Adequacy Review #3 / TR-05 / Lyons Quarry / M-1977-141

Attached is Technical Revision 5, Version 3 for your review. As in previous submittals, Attachment E-1, the Kleinfelder Stability Report, is not included due to its file size. The crosswalk spreadsheet will help identify the changes that were made to the document. We hope this revision satisfies the Division's concerns but please review and let us know if you have any follow up questions.

I'm attaching our adequacy review #3 letter for TR-05.

SHEET
01C-02

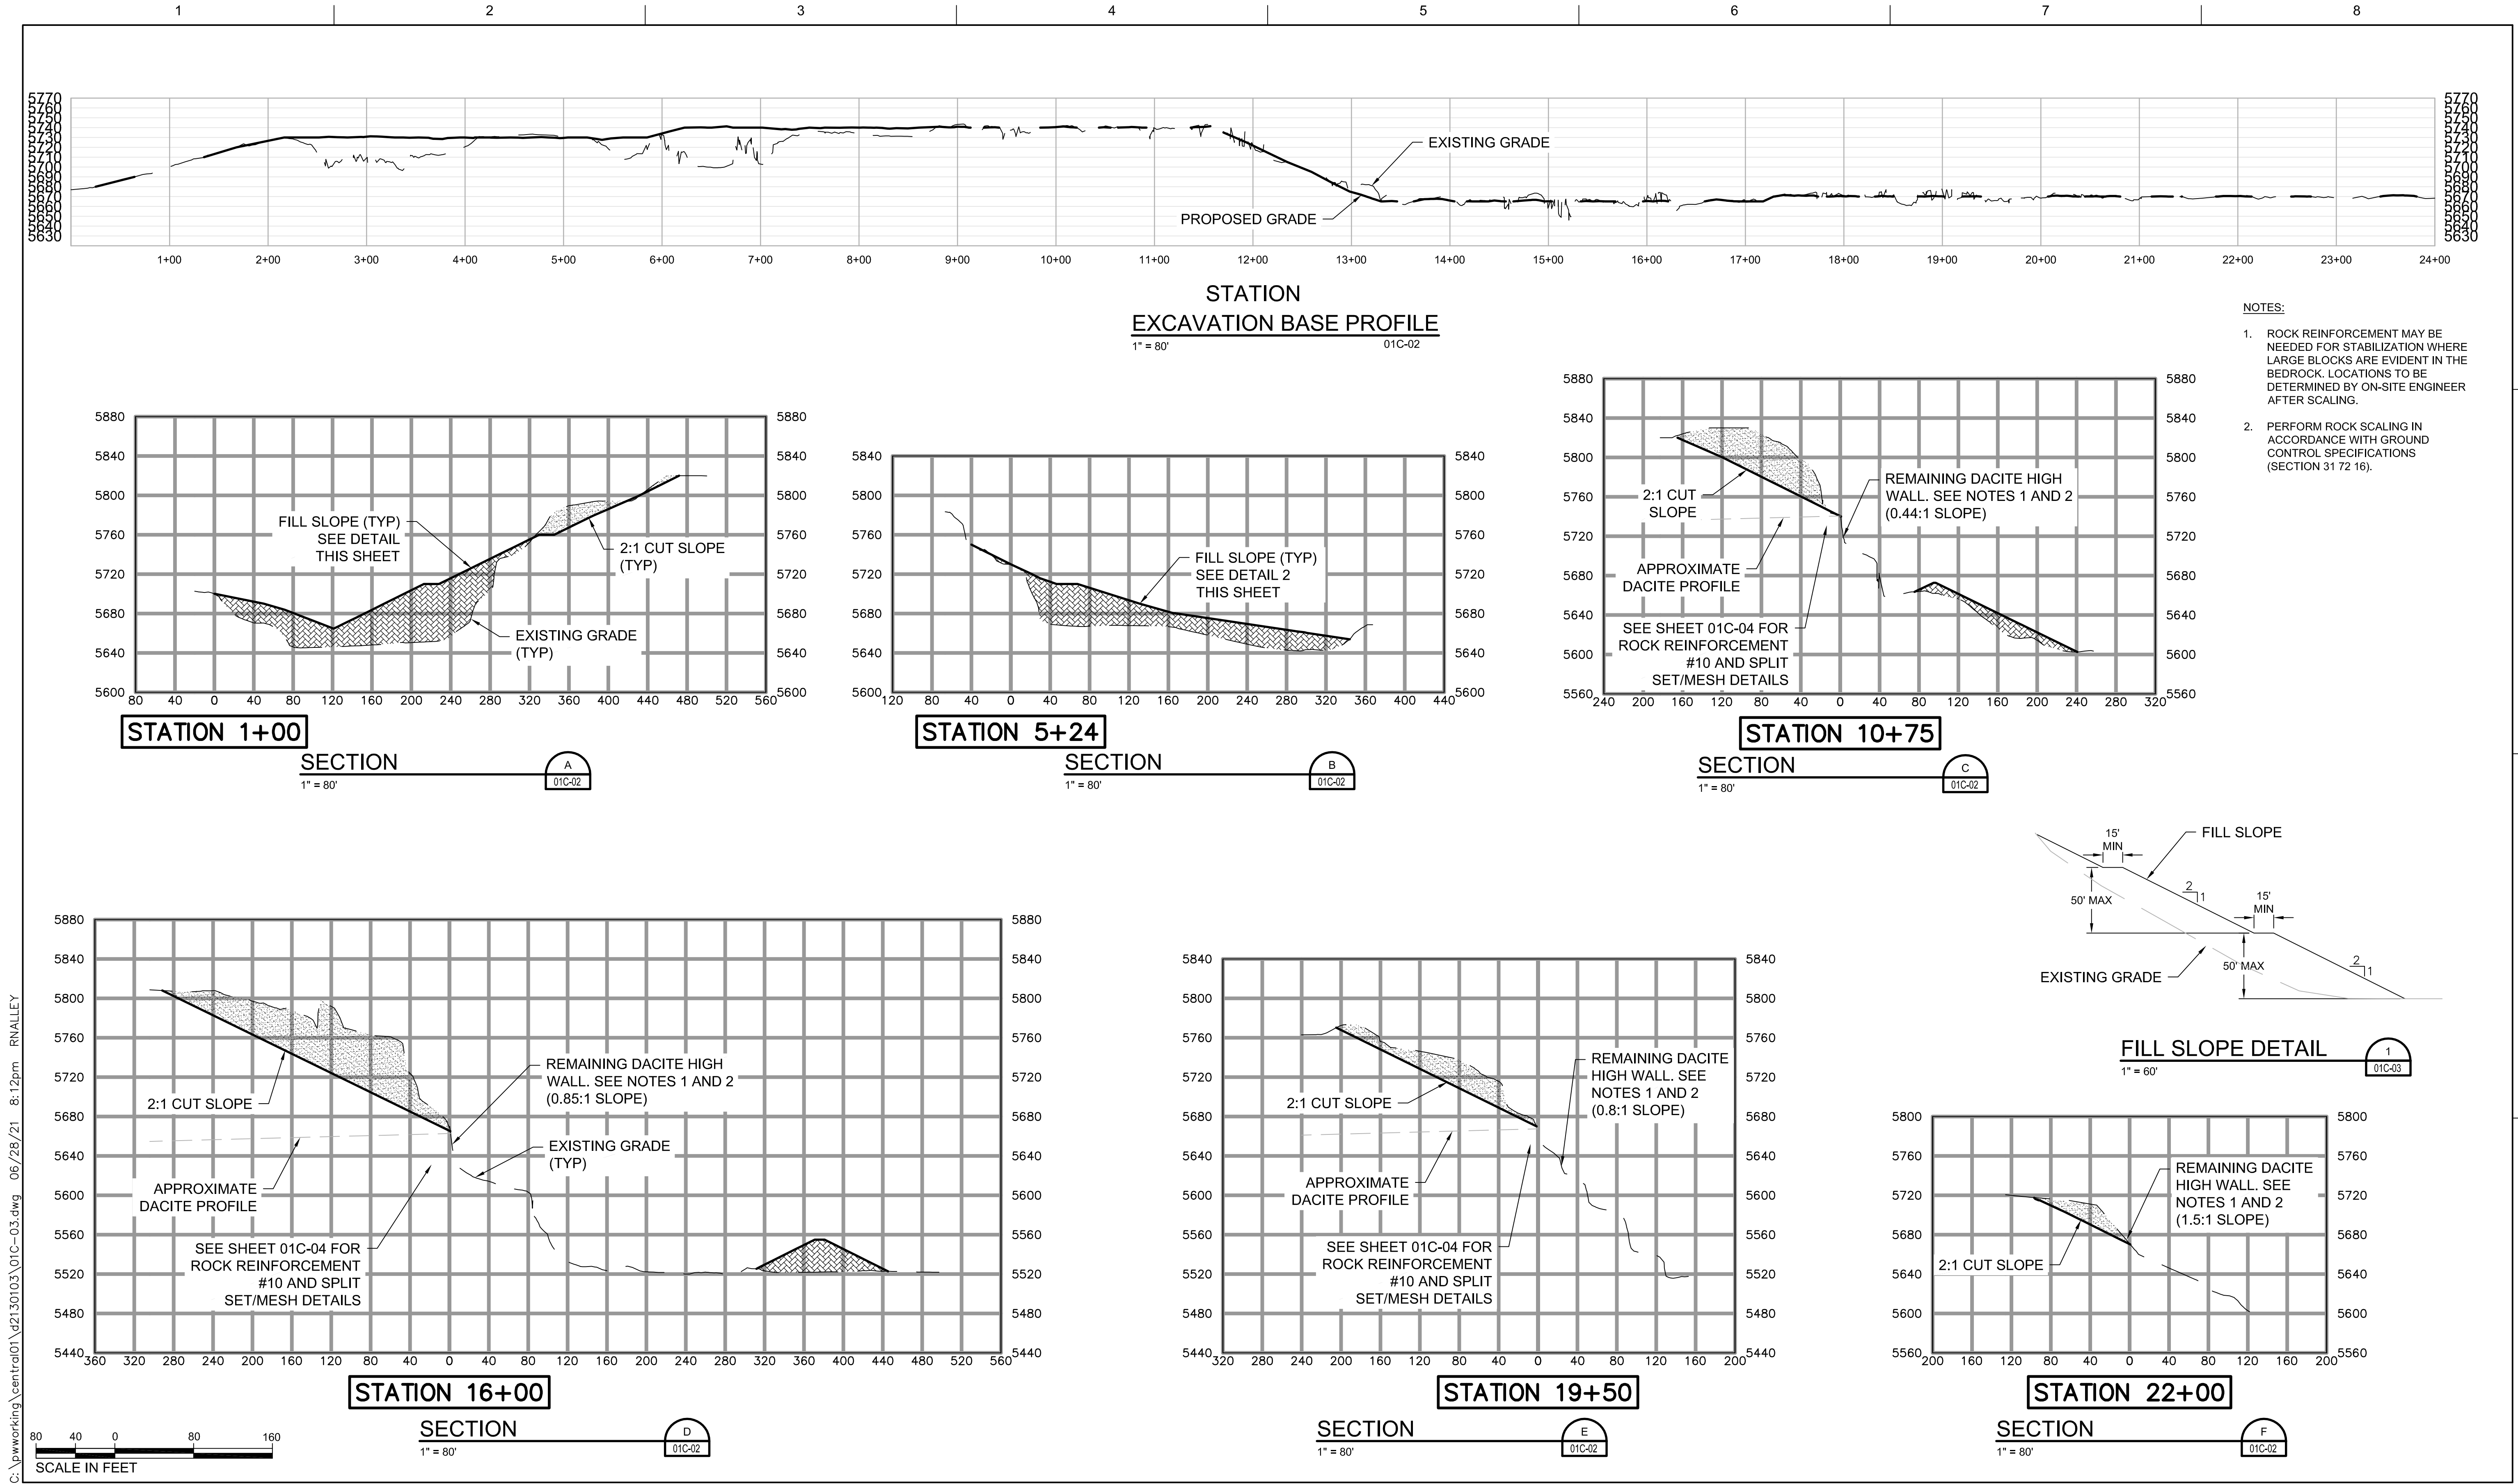
v.	Rock scaling: As rock scaling is an integral part of the reclamation plan, it would seem appropriate to include notes to perform rock scaling in accordance with project specifications on Sheet 01C-02, Site Grading Plan and/or Sheet 01C-03, Sections C, D and E.	Add notes for rock scaling to Sheets 01C-02 and 03	Sheets 01C-02 and 03
vi.	Rock anchors: The new note on Sheet 01C-02 does not completely reflect the inferred intent. The drawing note "Area to receive rock anchors as needed" should be revised to "Area to receive rock anchors as determined by engineer after rock scaling is completed and in accordance with project specifications". A callout referencing the new as yet unnamed detail on Sheet 01C-07 (Detail 6?) should also be added.	Call-out and revised note will be added to Sheets 01C-02 and 03. Add note to TR5 that an addendum will be added to the TR5 once the scaling of the highwall has been performed and a more thorough design of the rock bolt layout can be performed.	Sheets 01C-02 and 03. Section 5.1, Item 7

SHEET
01C-03

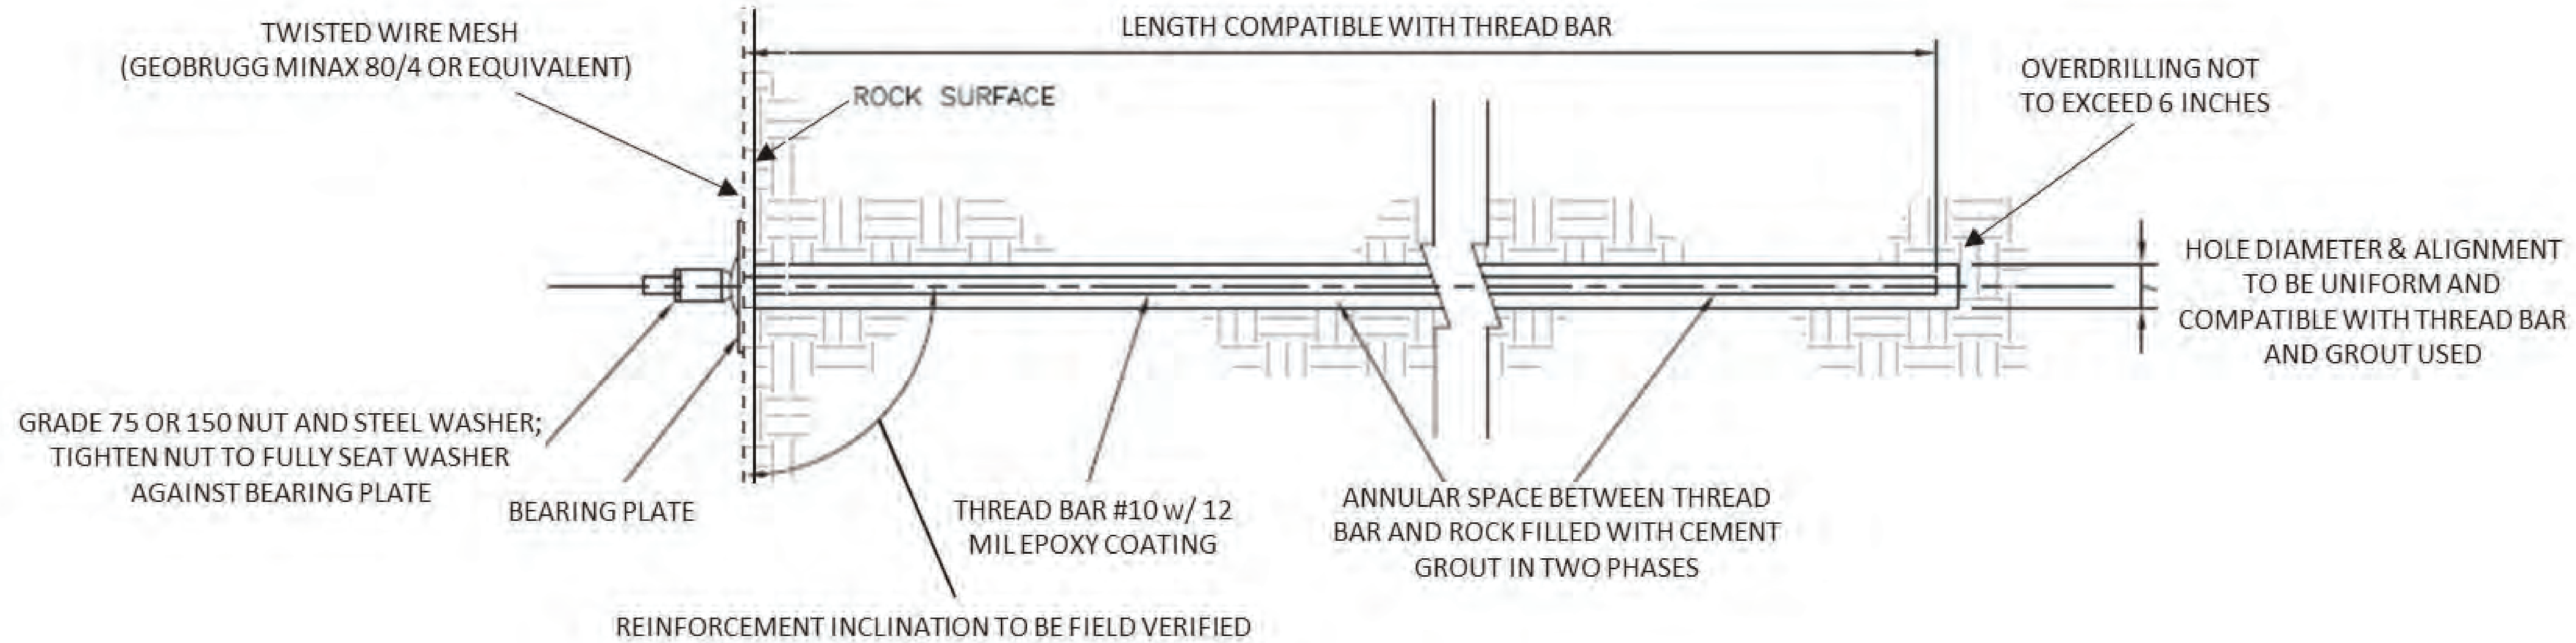
vii.	Final configuration of highwall: Section 5.1, Item 7 states "Details C, D and E show the proposed final configuration of the dacite highwalls" on Sheet 01C-03. These three sections are of a small scale using a dashed line and do not differentiate between the Fountain formation sandstone and the dacite. The "Remaining High Wall" should be revised to "Remaining Dacite High Wall" with references to "See Note 1" addressing the rock reinforcement.	Revise detail name, add call-out. Delineator will be added to the profile sections starting at crest of dacite and running in to hillside.	Sheet 01C-03 and new 04
viii.	Rock anchor Bolt Split Set & Wire Mesh Detail: As stated in Comment vi above, this detail on Sheet 01C-07 should be labeled as Detail 6(?) and provided with the proper symbology indicating it is called out from Sheet 01C-02.	Add call-out and detail for rock reinforcement on new page 01C-04.	New Sheet 01C-04
